MINERALS PROGRAM INSPECTION REPORT

MINE NAME: Cresson Project	MINE/PROSPECTING ID#: M-1980-244	MINERAL: Gold	COUNTY: Teller
INSPECTION TYPE: Monitoring	INSPECTOR(S): Timothy A. Cazier	INSP. DATE: July 19, 2016	INSP. TIME: 09:35
OPERATOR: Cripple Creek & Victor Gold Mining Company	OPERATOR REPRESENTATIVE: Clara Trippel	TYPE OF OPERATION: 112d-3 - Designated Mining Operation

Photo 1. Secondary infiltration trench on north side of Phase IV AGVLF (looking west).

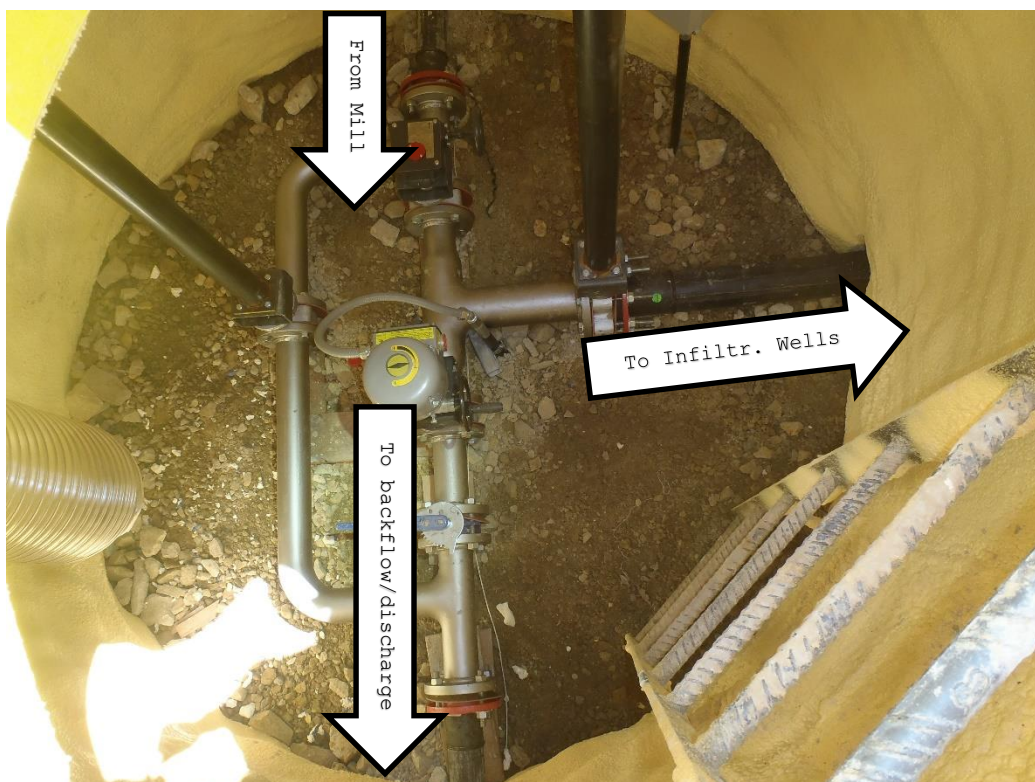
- a) Mill Discharge – The area observed collecting mill water discharge during the June 16, 2016 inspection (see **Photo 1**) was a result of valve in the discharge “can” (see **Photo 2**) not being properly seated. Mr. Rodabough indicated this problem had been corrected and the manual valve that allows the pipes to the AGVLF infiltration wells to back drain should flow to the infiltration wells need to be stopped is now in the closed position. He indicated the only time the mine would need to allow backflow to drain to the pond area would be if the infiltration wells were not working and/or there was danger of the pipe lines to the infiltration wells freezing.
